RE: CPV Sentinel Energy Project  
Application for Certification 07-AFC-3

- Twenty-five printed copies of the CPV Sentinel Energy Project Response to Data Requests (35, 38, 43, 50, 60, and 62 through 65)
- Fifty CDs containing the CPV Sentinel Energy Project Response to Data Requests (35, 38, 43, 50, 60, and 62 through 65)

**APPLICATION FOR CERTIFICATION  
FOR THE CPV SENTINEL ENERGY  
PROJECT  
Power Plant Licensing Case**

**MSWD's Horton WWTP Percolation Ponds**

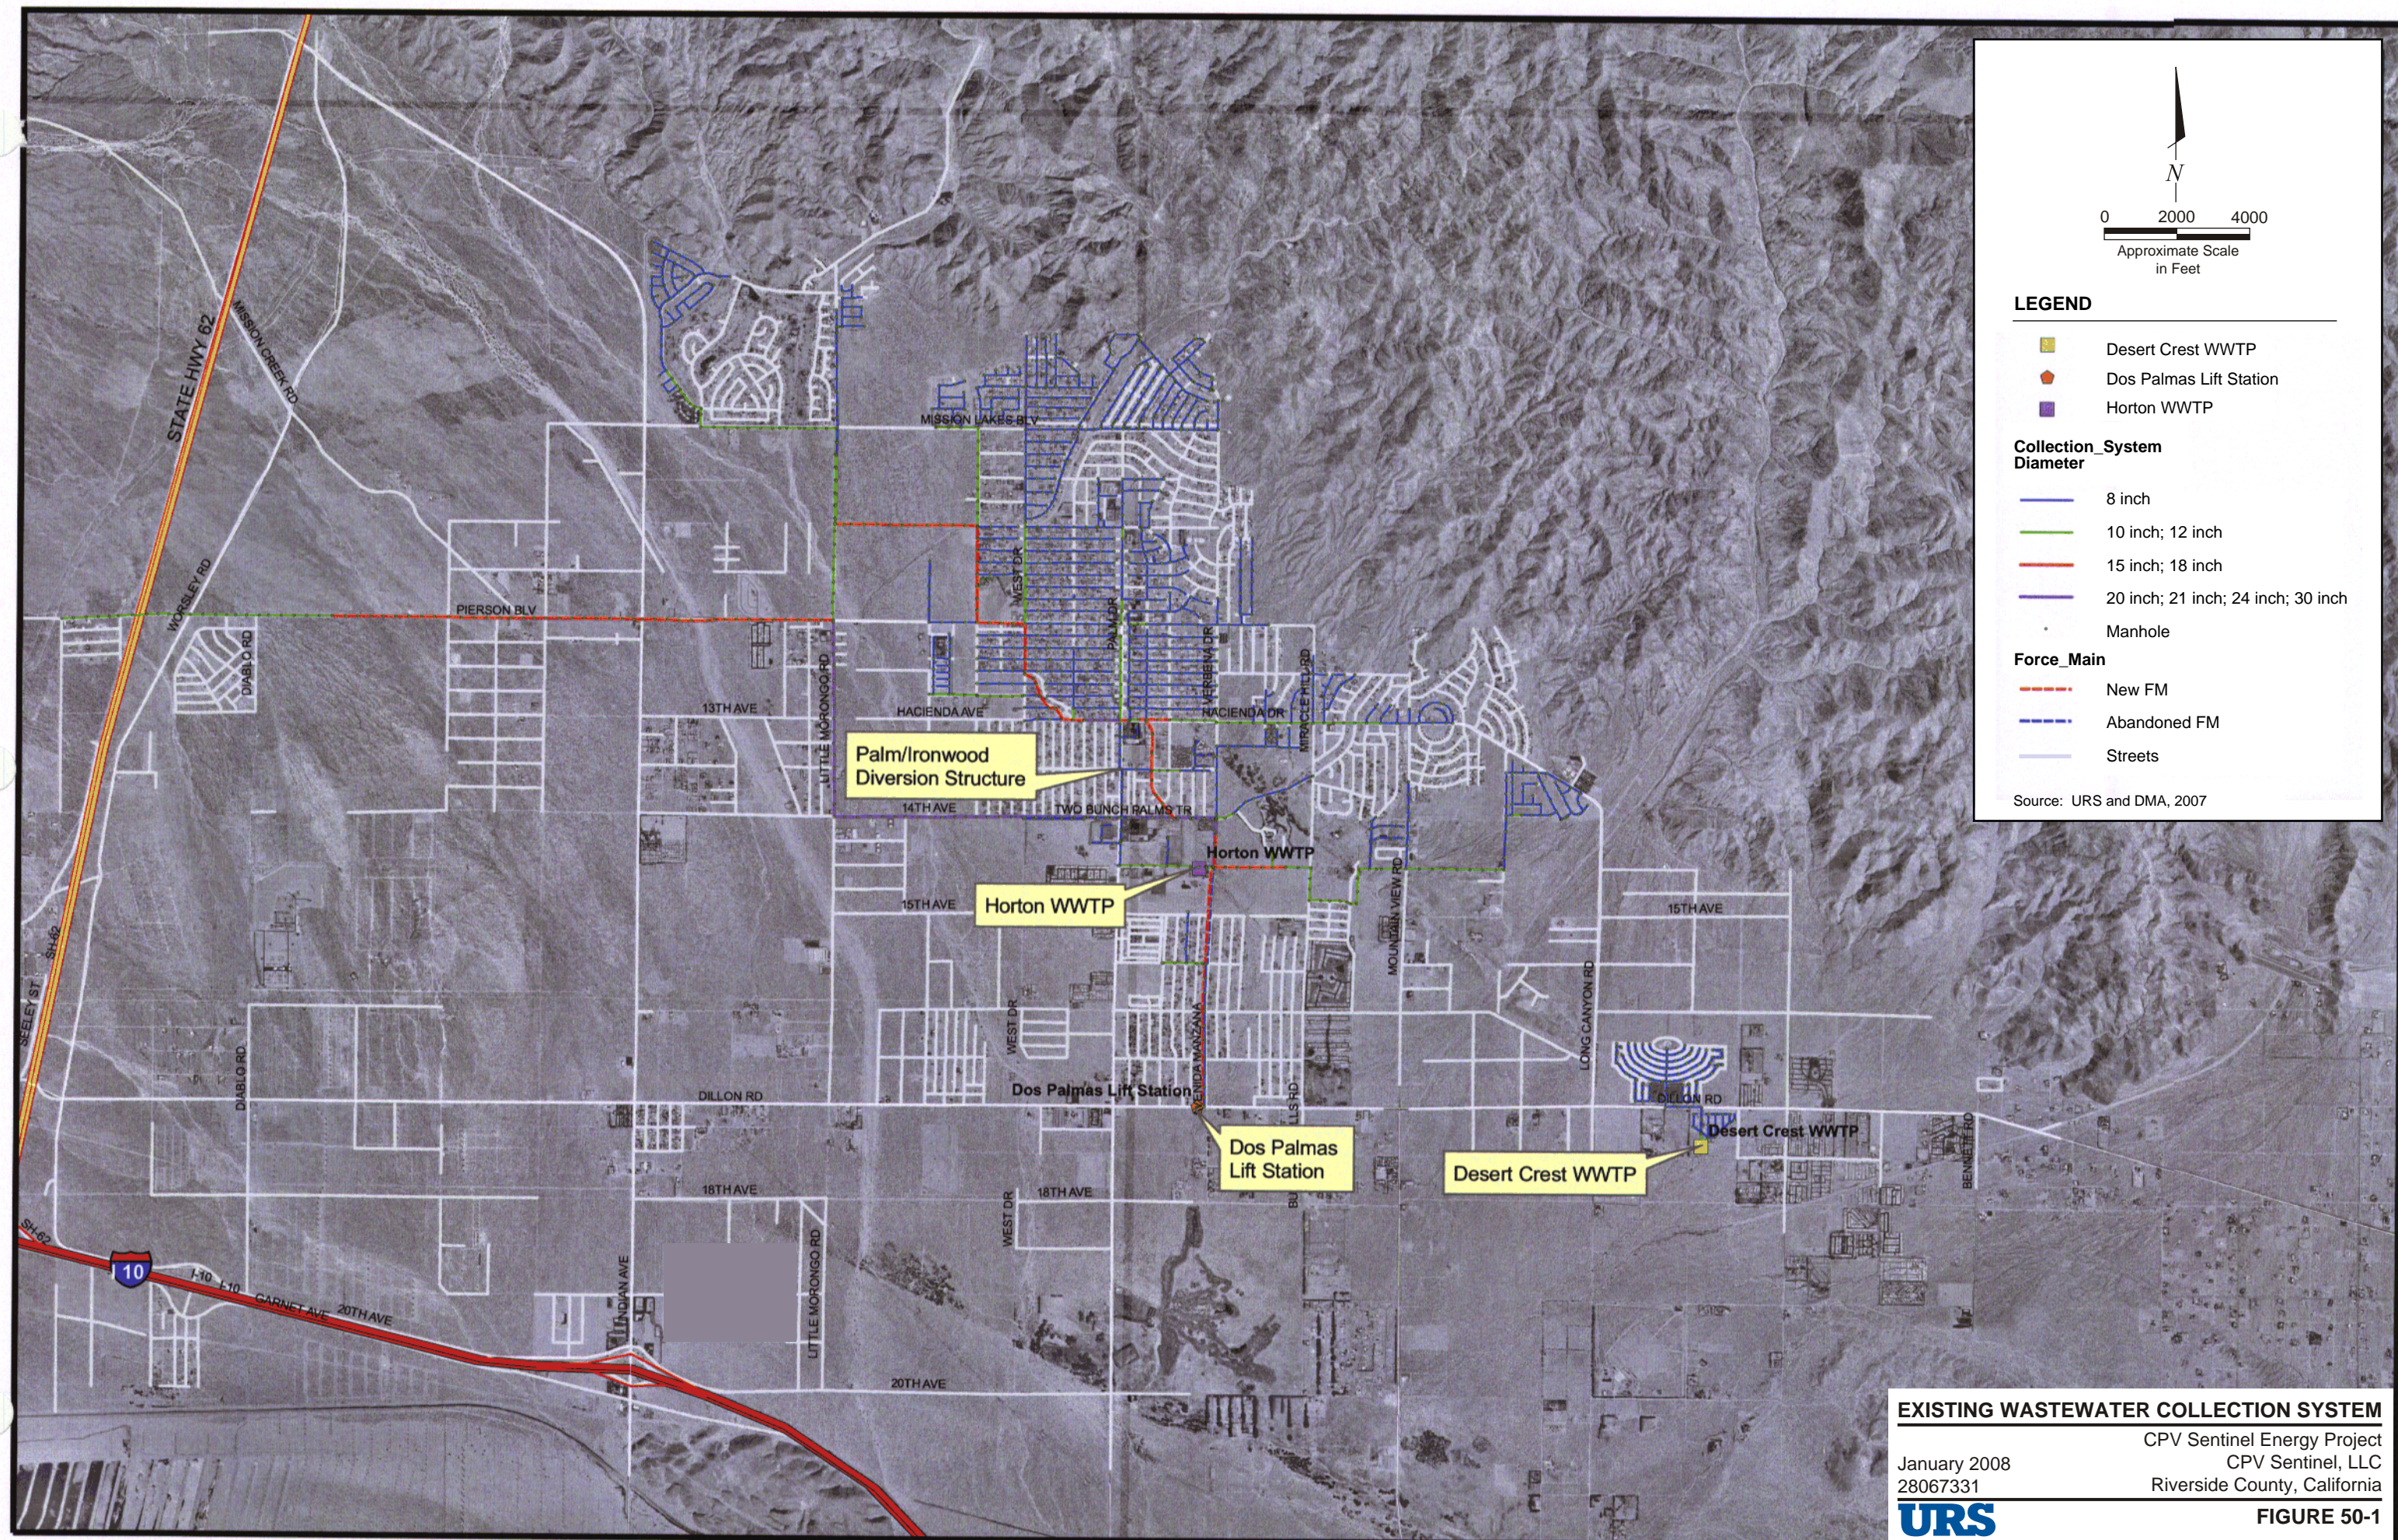
**50. Please provide a description of the site-specific hydrologic and geologic conditions of the Horton WWTP percolation site. The purpose of this request is to obtain information necessary to assess the hydrologic effect of the percolation. Please include the following information:**

- g) See previously submitted responses. No additional information.
- h) See previously submitted responses. No additional information.
- i) The previously submitted responses reported that the acreage of the existing Horton WWTP percolation ponds is approximately 5 acres, based on aerial photos. According to Earth Tech, Inc, (2007), the five existing percolation ponds have an infiltration area of approximately 4 acres (see Figure 50-4).
